Monterey Plus Final Revised EIR

Final Revised Environmental Impact Report

Monterey Amendment to the State Water Project Contracts (Including Kern Water Bank Transfer) and Associated Actions as Part of a Settlement Agreement (Monterey Plus)

Document A2 (2016 Monterey Plus Final Revised EIR – Kern Water Bank Development and Continued Use and Operation)

(Table 1)

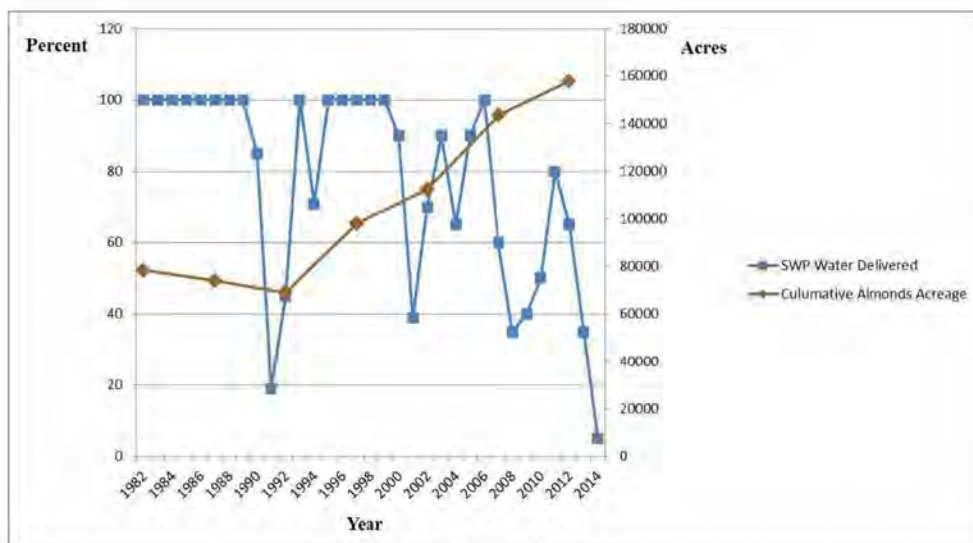
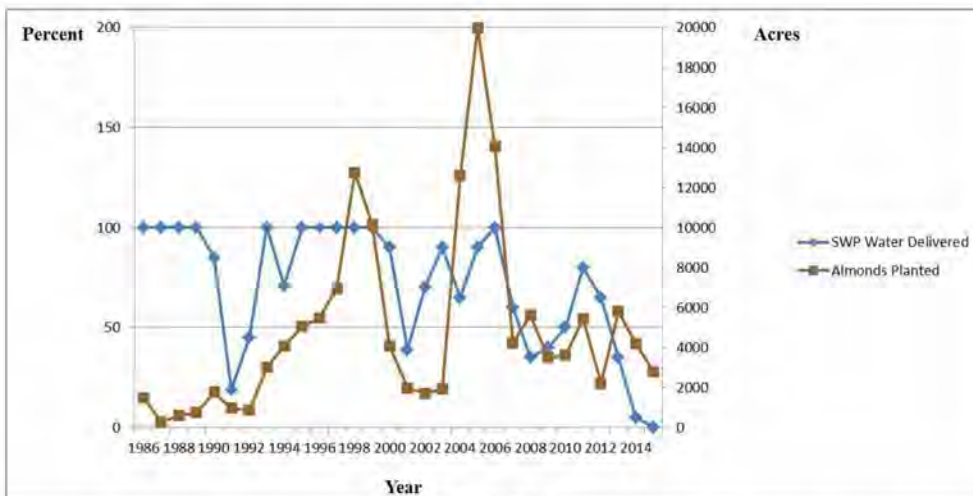
The graphs in Appendix E of the Revised EIR illustrate the clear connection between the KWB Transfer and the region's conversion from annual crops to permanent crops. (See Revised EIR at E-43 to E-46.) This correlation is readily apparent in Tables 1 and 2, below. Table 1 depicts the cumulative growth in the total acreage of almonds in Kern County, based on the U.S. Department of Agriculture ("USDA") Census data from 1982 to 2012,³ compared to the percentage of allocation (percentage of Table A requests delivered). (Revised EIR at E-44, Table 7.)⁴ Table 2 depicts the amount of new almond acreage planted each year in Kern County⁵ compared to the percent of SWP allocation. The tables show that the growth in cumulative acreage and increase in newly planted acreage of almonds in Kern County is an almost direct result of the KWB Transfer. (See Table 1 and 2.)

The Department disagrees. The commenter cites their Tables 1 and 2 to show growth in almond acreage in Kern County. The tables are based on U.S. Department of Agriculture (USDA) data from 1982 to 2012 (USDA 2016b). These two tables are then compared to SWP water deliveries and the commenter concludes that there is a correlation between the SWP deliveries and an increase in almond acreage. (see **Figures 4-1a, 4-1b, 4-2a, and 4-2b** based on USDA [2016b] and California Department of Food and Agriculture [2016]).
